Machine Service Bulletin No. 430

MODEL: LA-5 and LA-6

SUBJECT: Automatic Division Shift Cam Movement

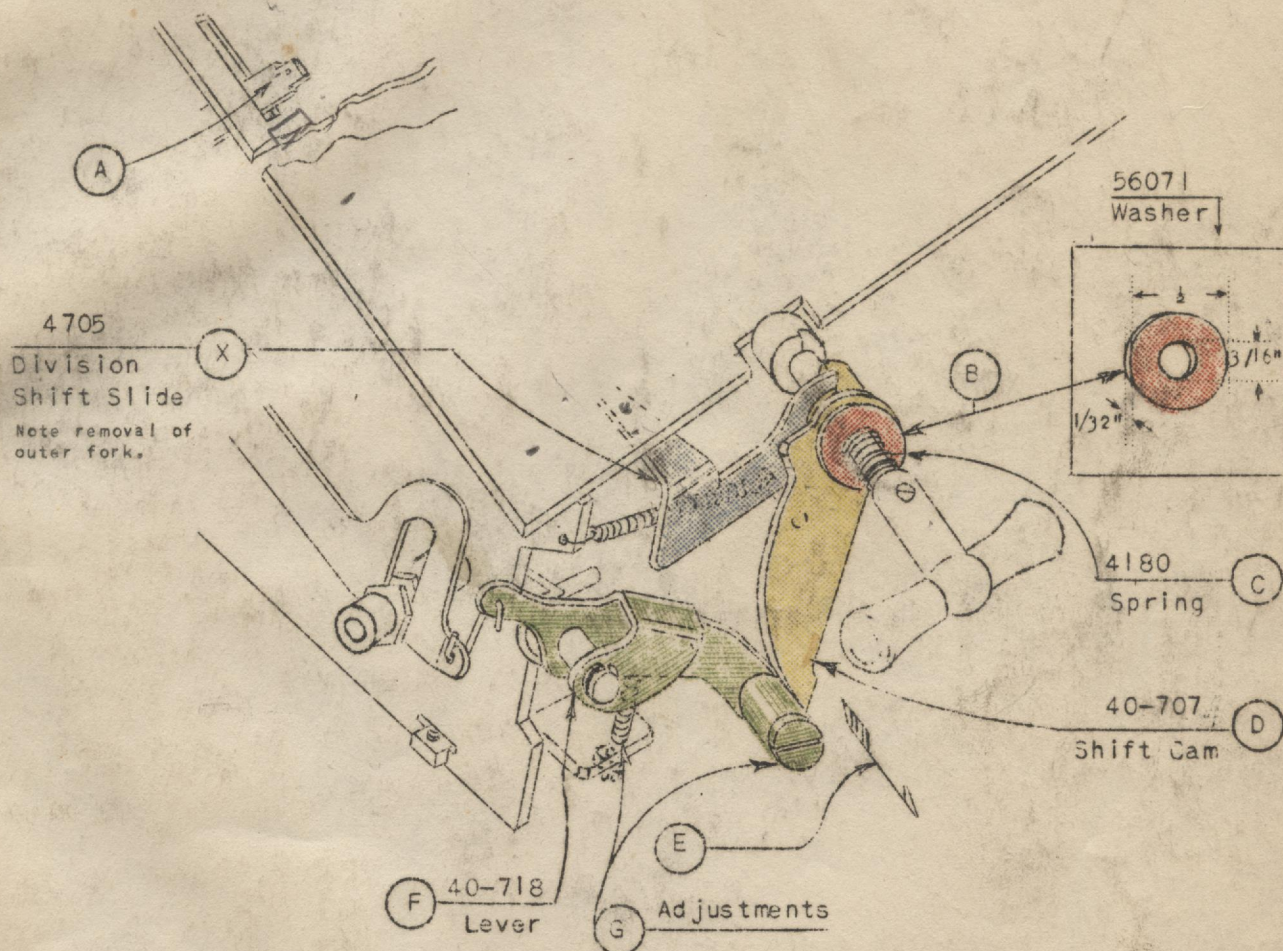
A 56071 spacing washer (B) is being installed in current LA-5 and LA-6 machines between the 40-707 shift cam (D) and the 4180 spring (C) to eliminate the possibility of (D) moving too far in the direction of arrow (E) when the division lever (A) and 4705 slide (X) are automatically restored to neutral position.

It is important that the 40-718 lever (F) and 40-707 shift cam (D) are properly adjusted at (G) and aligned in relation to each other.
